CATS-M Cantonment Roads & Parking Construction Project

PROJECT NO. 31090657

A D D E N D U M N O . 1

Additional Project Info:

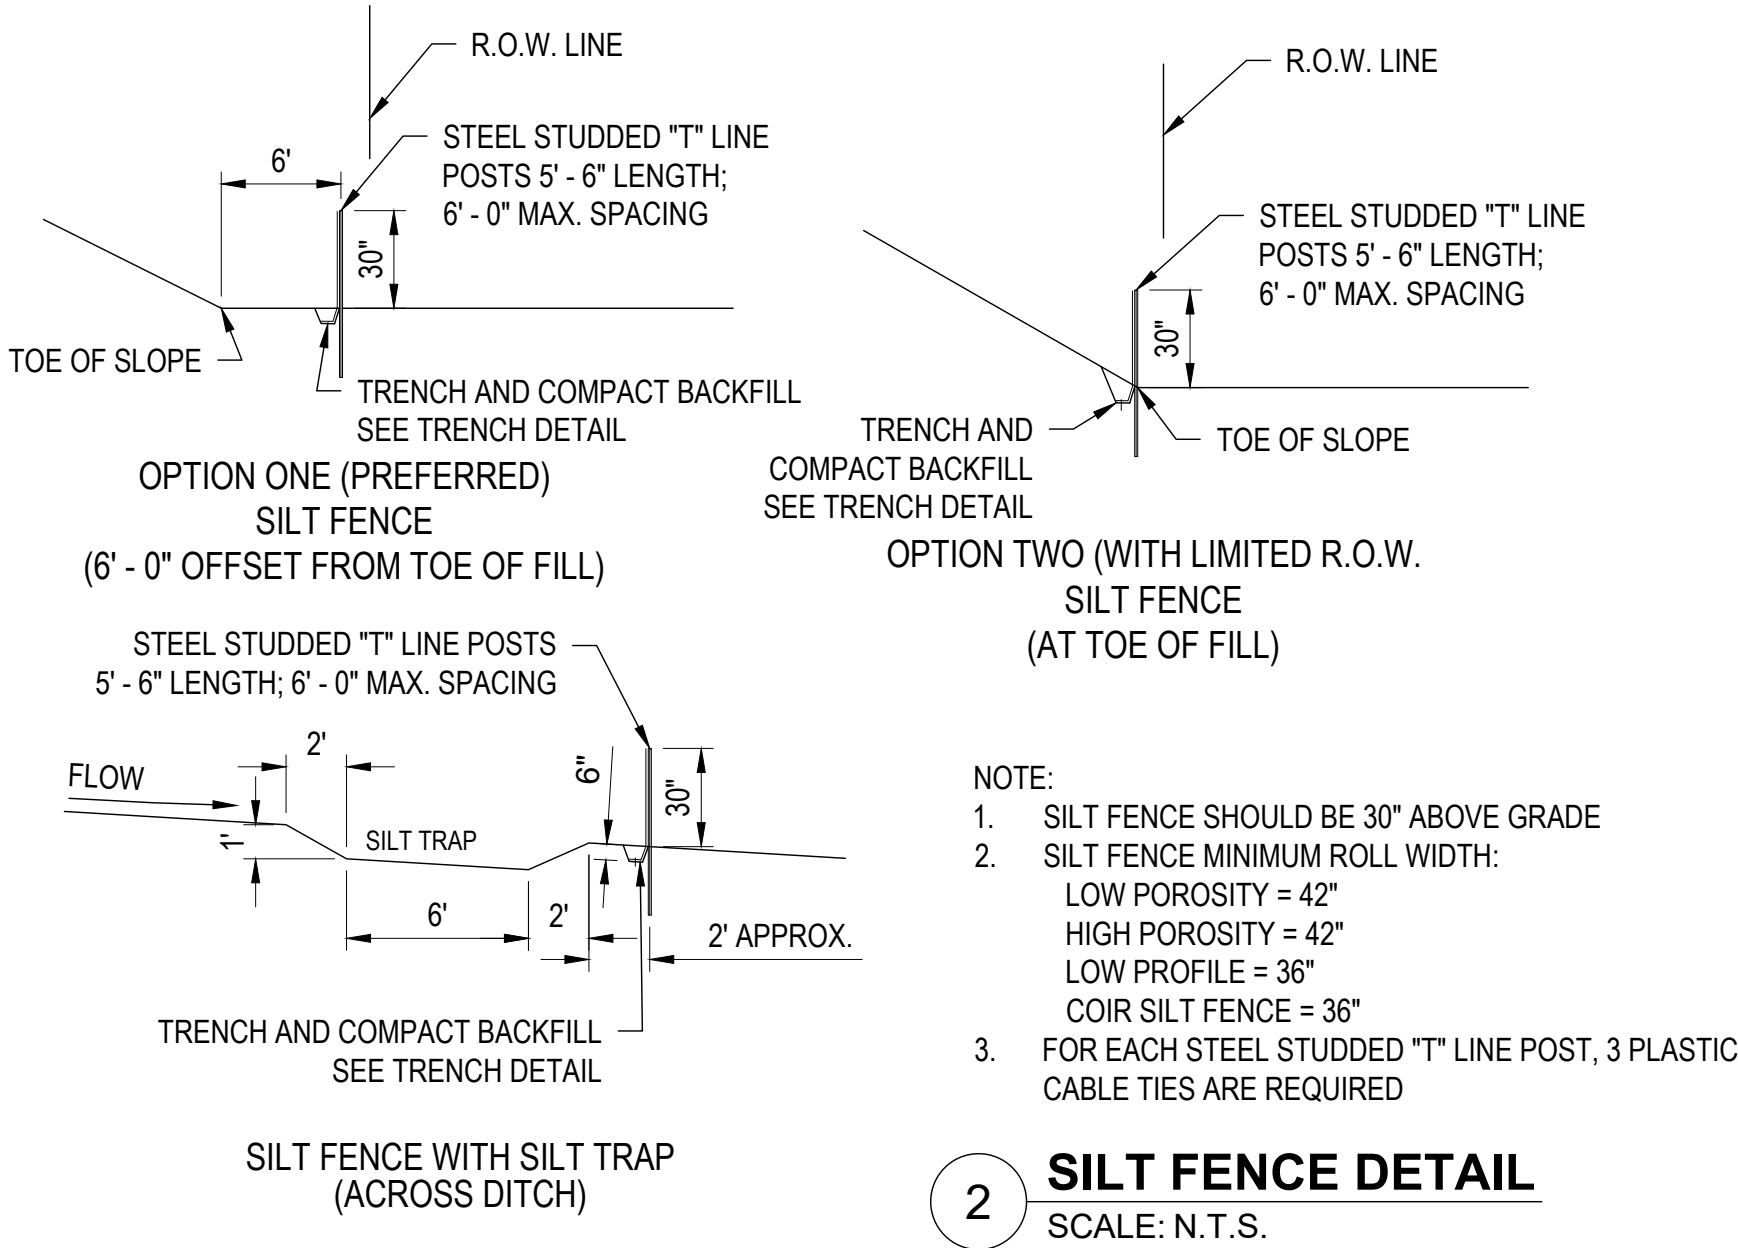
1. Sheets G001 (Cover) and D200 shall be deleted and replaced with the attached revised sheets to include manhole detail, bearing revision number 1.

- All manholes shall be raised to the proposed grade of the new roadway. Please reference plan sheets C300 and C301 for proposed elevations.
- See revised sheet D200 for manhole detail.

TYPE B
UNDER FENCES

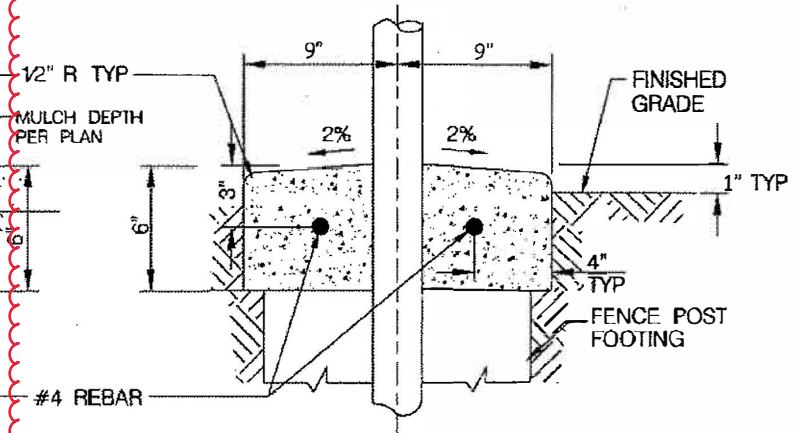
1. Add the attached Nebraska Army National Guard Standard Drawing NEARNG-101, "Concrete Mowing Strip," to the Contract Drawings. For concrete mowing strips required by the Contract Documents, use Type B – Under Fences. Type A – All Areas Except Under Fences is not used. In the event of a conflict between the attached detail and the original Bidding Documents, the attached detail shall govern.

- Geofabrics and geogrids shall not be an acceptable replacement for the subgrade preparation called out in the plan's typical sections.
- See attached for Concrete Mow Strip Detail. Type B Detail shall be used underneath the fence.
